Docket Item # 9
BAR CASE # 2009-0176

BAR Meeting
October 21, 2009

ISSUE: Permit to Demolish
APPLICANT: Scott Management Inc.
LOCATION: 620 Jefferson Street
ZONE: RCX

BAR CASE #2009-0150/0176

Figure 3: 605 Jefferson Street

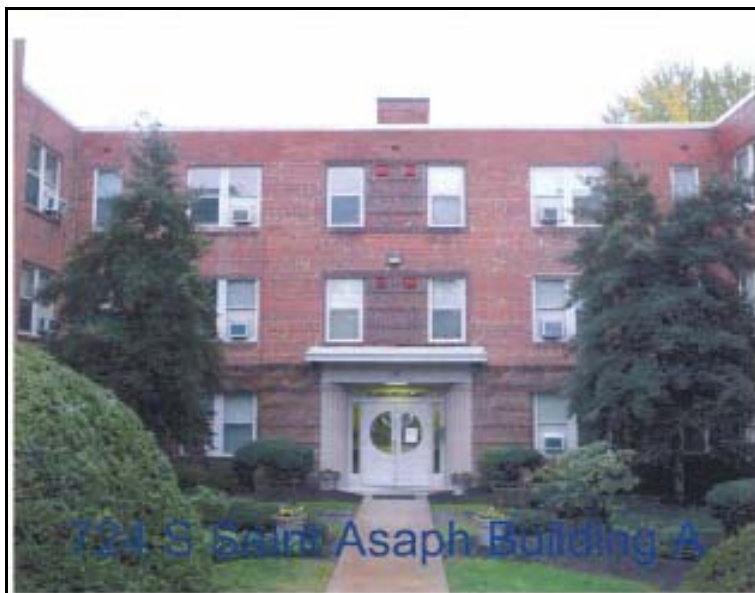
The BAR has approved the use of the same type of wall units on several of the adjacent properties. The BAR approved of the use of wall mounted units at 1) the Old Town Gardens Apartments located at the corner of South Washington Street, and Jefferson Street, *see* photos attached Exhibit "D", and the Bearings Apartments location at 820 A&B S Washington and one building on Green Street, *see* photos attached as Exhibit "E". As the attached Exhibit "F" shows, the BAR has approved of the use of similar units on the facades of both of the adjacent properties.

Exhibit E

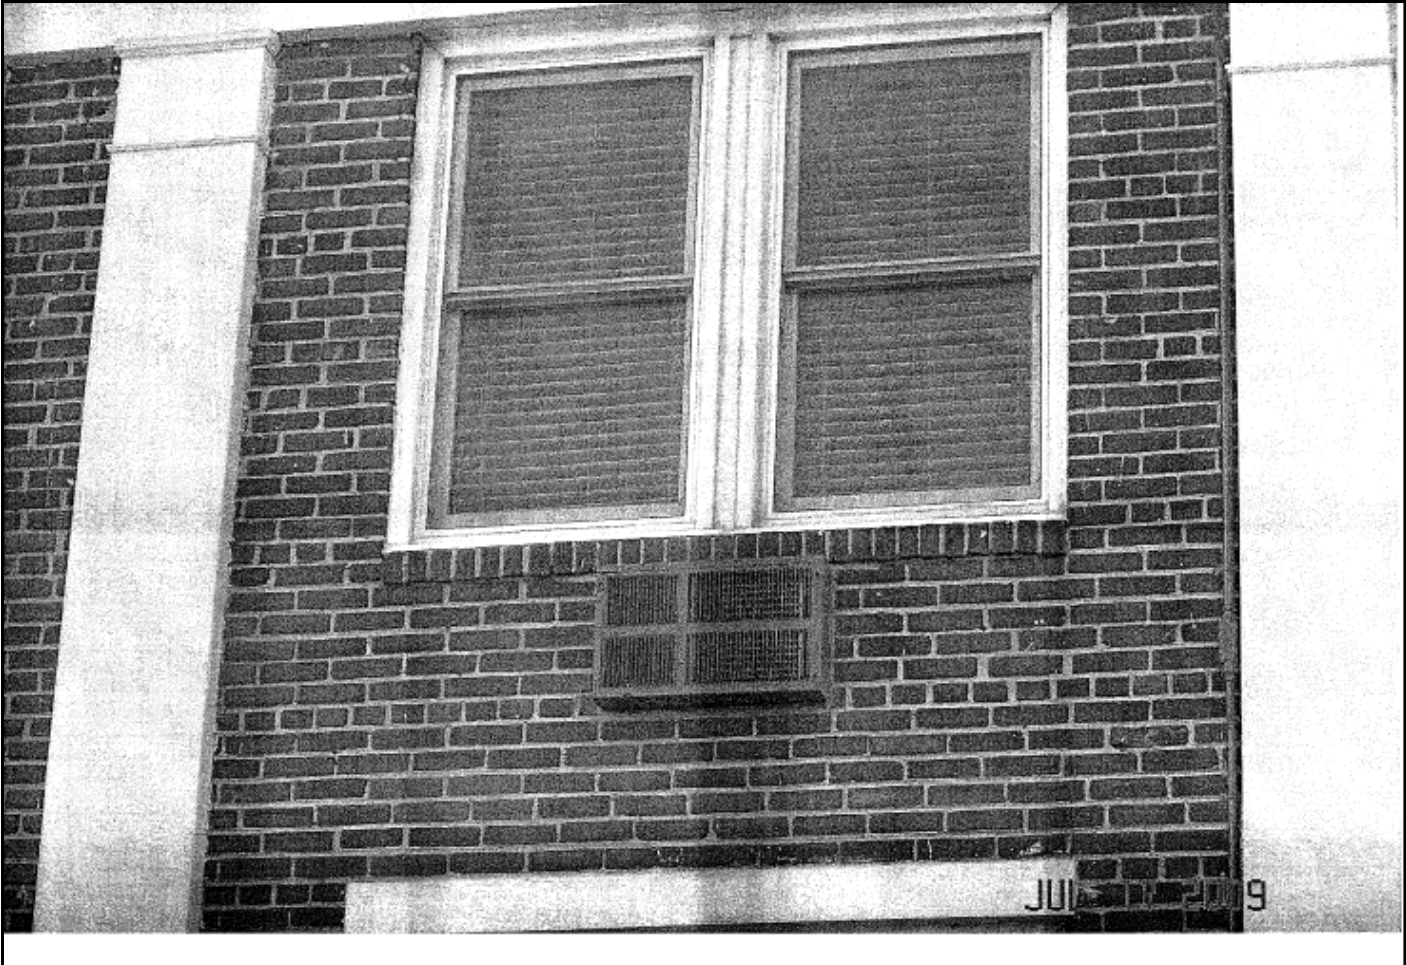
The Board also asked the Applicant to examine typical heat pump systems where the condensers are mounted on the ground. The Applicant has examined this option and this option would cost approximately \$600,000 more than the proposed wall units. In addition to the increased cost, the Property does not contain adequate space to locate the condensers on the ground and to screen them from view, nor is there space inside the apartments to build a utility closet to contain the necessary ventilation equipment. See Site Plan, attached as Exhibit "E". As such, this option is cost prohibitive and not feasible.
